SUBJECT: TECHNICAL EVALUATION REPORT FOR DRAFT WASTE DETERMINATION
FOR SALT WASTE DISPOSAL

U. S. NUCLEAR REGULATORY COMMISSION
TECHNICAL EVALUATION REPORT FOR
THE U.S. DEPARTMENT OF ENERGY SAVANNAH RIVER SITE
DRAFT SECTION 3116 WASTE DETERMINATION FOR
SALT WASTE DISPOSAL

December 2005

Figure 5 Engineered Closure Cap Side View

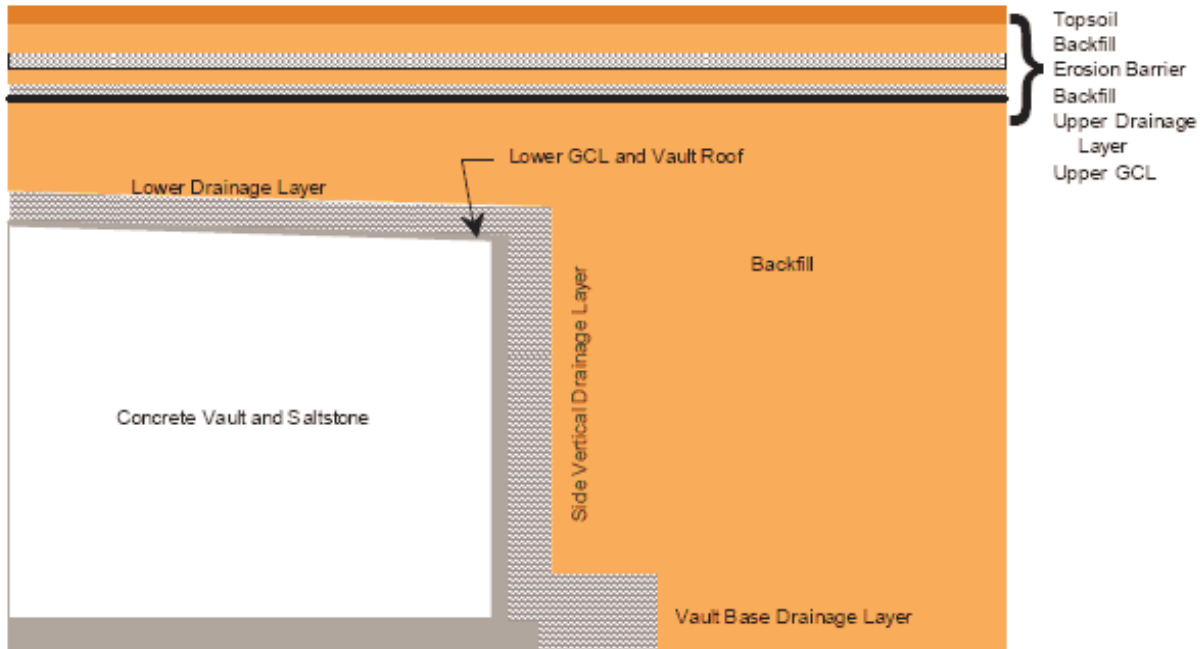
An independent NRC analysis suggests that the model used by DOE to estimate the effects of colloidal clay plugging the lower drainage layer may not be conservative. If the hydraulic properties of the lower drainage unit are modified uniformly throughout the layer to reflect partial plugging by colloidal clay, open-fracture flow may be allowed in less than a third of the time predicted by the DOE model, in which complete plugging occurs in a discrete sublayer within the lower drainage unit. The NRC staff expects that colloidal clay transport will result in the highest degree of clay deposition occurring at the top of the lower drainage layer, with clay deposition that may be smeared from the sharp front implied by the DOE model. The NRC staff recognizes that the rates of colloidal clay transport used by DOE are based on literature values (Phifer and Nelson, 2003), while the soils at the SRS have low pH values that may modify colloidal transport. Because the integrity of the lower drainage layer behavior affects every fracture, uncertainty in drainage layer behavior is expected to be important to performance. Uncertainty in the estimated rate of degradation of the lower drainage layer could be reduced through further studies or could be mitigated through additional conservatism in cap design.

Figure 6 Engineered Closure Cap Layers

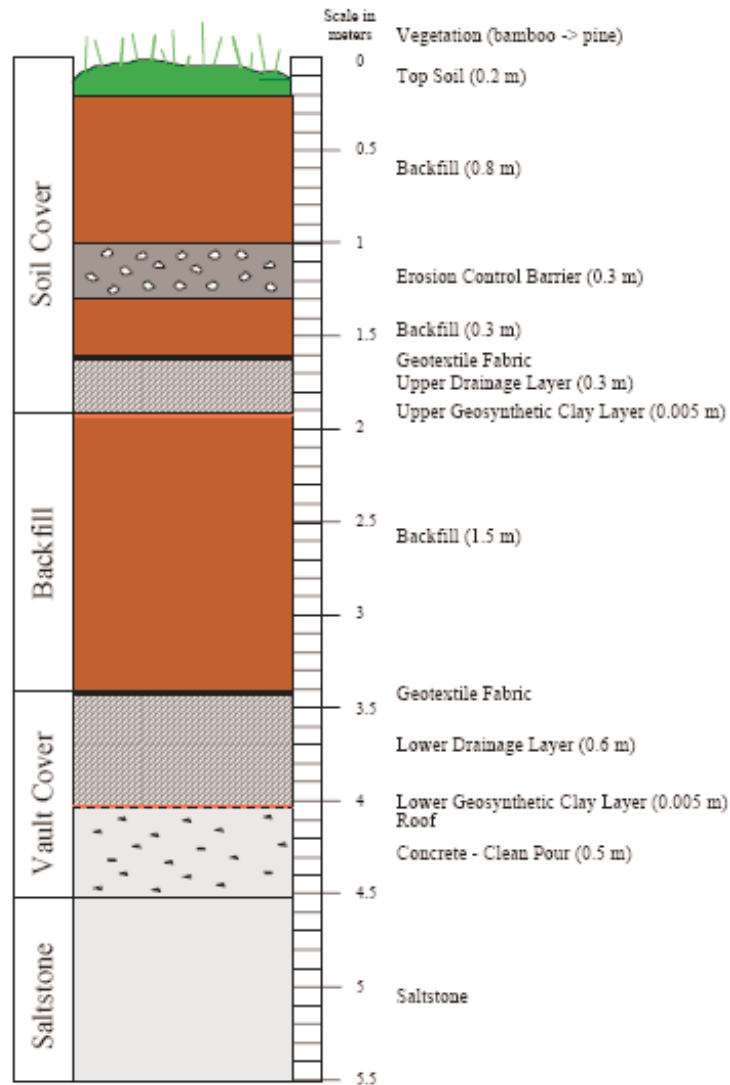
Staff reviewed the DOE calculations for stability of the top slope, side slopes, and apron. Based on review of the calculations, the conservatism associated with the design discharge, and the ability of the cover to provide adequate protection against the computed velocities and shear stresses, the staff concludes that the top slope should be stable under extreme flooding conditions. The proposed rock size for the side slope is adequate, and the apron design is acceptable (based on the conservatism associated with the computation of flow rates). Based on the acceptability of using procedures suggested in NUREG-1623, the riprap design should achieve the objectives. In addition, the proposed information and procedures are sufficient to ensure acceptable placement of the riprap and fill into the riprap voids.

Based on review of the information submitted by DOE and on independent calculations, the NRC staff concludes that DOE has provided sufficient information to conclude that the erosion protection design is adequate to provide reasonable assurance of long-term stability of the closure cap for erosion control purposes. It should be emphasized that DOE has provided a conceptual design, and this design could change in the future, depending on the number and location of vaults. Staff's conclusions on this conceptual design is based largely on the conservatism associated with the design, as proposed. There may be several individual design parameters which may not be acceptable if some of the other conservative design parameters are changed or removed. When making design changes, DOE should ensure appropriate conservatism is maintained.

Figure 7 Comparison of PORFLOW and Slag Lysimeter Data

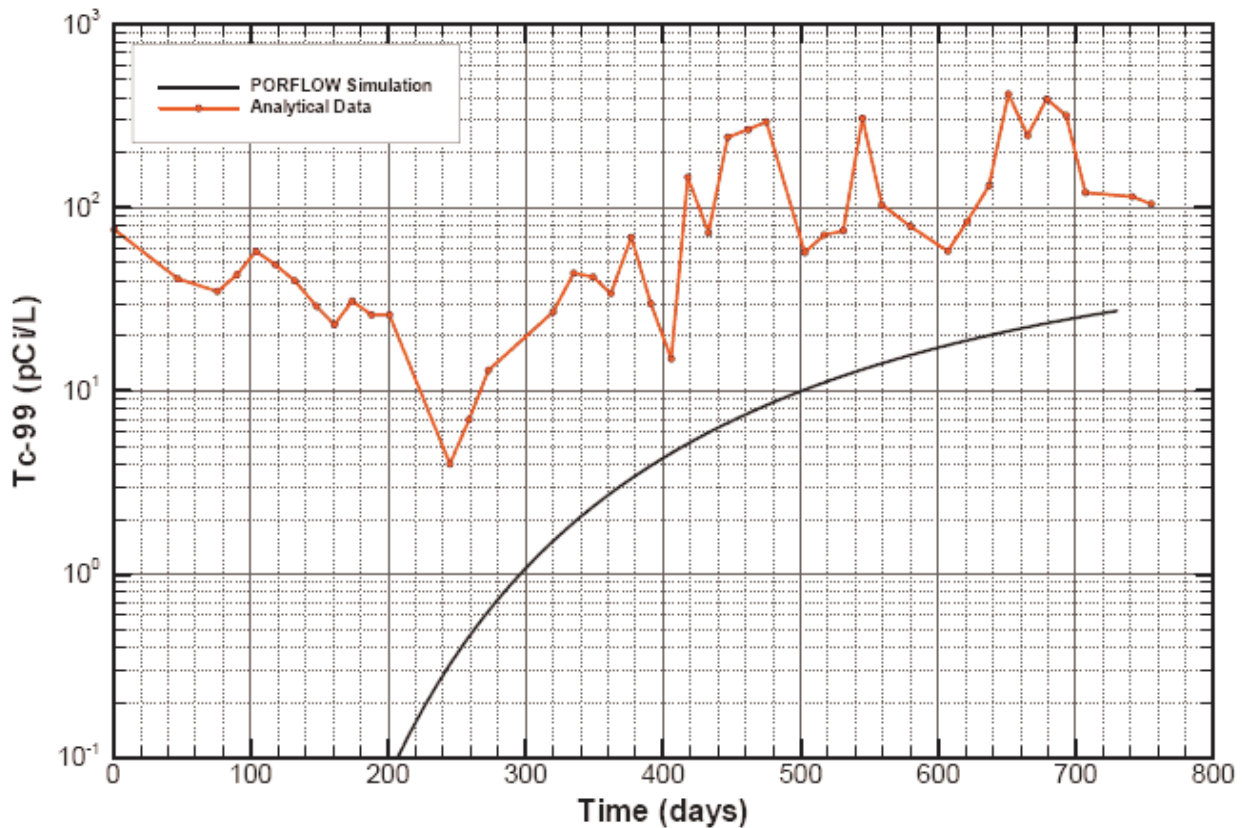
Model support is essential for deterministic modeling that is not clearly conservative because uncertainties are not represented in a deterministic analysis. Model support is information that provides confidence that the numerical model results are adequately representing the behavior of the actual system. Model support is commonly called model validation in the technical literature, but NRC recognizes that some aspects of PA are not amenable to scientific model validation (e.g., the long time frames) (NRC, 2000b). Model or software verification is a process to ensure that the numerical calculations are correct, but it does not ensure that the model results are appropriate for the given application. It does appear that DOE has performed adequate software verification for the main products it used to complete the PA (e.g., PORFLOW, HELP, internally developed intruder analysis software). NRC requested additional model support for key areas of DOE's PA in the RAI (NRC, 2005a). DOE stated that the information provided in (WSRC, 2005b) encompasses all currently available field data providing model support for the simulation results. A path forward that outlined how DOE intended to develop adequate model support was discussed in the August 17, 2005, meeting; however, a path forward was not provided in the written response to the action items (WSRC, 2005a).

The following example is intended to illustrate the types of information that could be developed to provide adequate model support. One of the key elements of DOE's PA is the reduction of Tc-99 in the wastefrom by the addition of slag. As previously discussed, the sensitivity analyses demonstrate quite clearly that the rate and extent of oxidation of the wastefrom is a key factor in meeting the protection of the public performance objective. DOE has performed basic research to evaluate whether the slag would result in Tc-99 being contained in a reduced form, and installed field-scale saltstone lysimeter tests with and without slag (Cook and Fowler, 1992). The slag-based lysimeters showed a much lower release rate of Tc-99 compared to the lysimeters without slag. At the request of NRC, DOE provided a comparison of a PORFLOW simulation with analytical data, that showed an underprediction by the model of roughly a factor of 10 (WSRC, 2005a). Figure 7 provides the comparison of the PORFLOW and slag lysimeter data. DOE explained the underprediction was the result of the analytical measurements being performed for gross non-volatile beta-gamma emitters, and therefore the results show essentially background. However, the data shows an increasing trend starting around day 250 that is consistent with the PORFLOW simulation, therefore it is unclear that the analytical data represents background. In addition to providing information on field-scale release rates, the slag lysimeters may contain valuable information about the rate of oxidation of the saltstone. Currently, DOE's estimates for the amount of oxidation of the saltstone over 10,000 years are based primarily on numerical modeling results. It may be possible to exhume and characterize a saltstone lysimeter. The depth of the penetration of the oxidation front should be able to be estimated and it would provide excellent model support for a key element of DOE's PA.
